TRANS/WP.29/2003/67
17 July 2003

PROPOSAL FOR DRAFT SUPPLEMENT 8 TO REGULATION No. 43

(Safety glazing)

Transmitted by the Working Party on General Safety Provisions (GRSG)

"Safety glazing having a regular light transmittance < 40 per cent

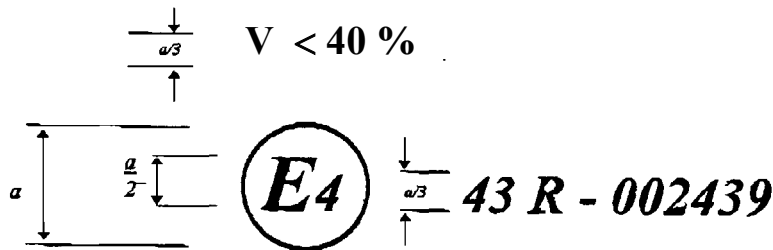
Annex 2A, add after the approval mark a new example for safety glazing having a regular light transmittance < 40 per cent, to read:

The above approval mark affixed to a safety glazing with a regular light transmittance of less than 40 per cent as determined by the test described in annex 3, paragraph 9.1., shows that the component concerned has been approved in the Netherlands (E 4) pursuant to Regulation No. 43 in its original form under approval No. 002439. The approval number indicates that the approval was granted in accordance with the requirements of Regulation No. 43".

a = 8 mm min.
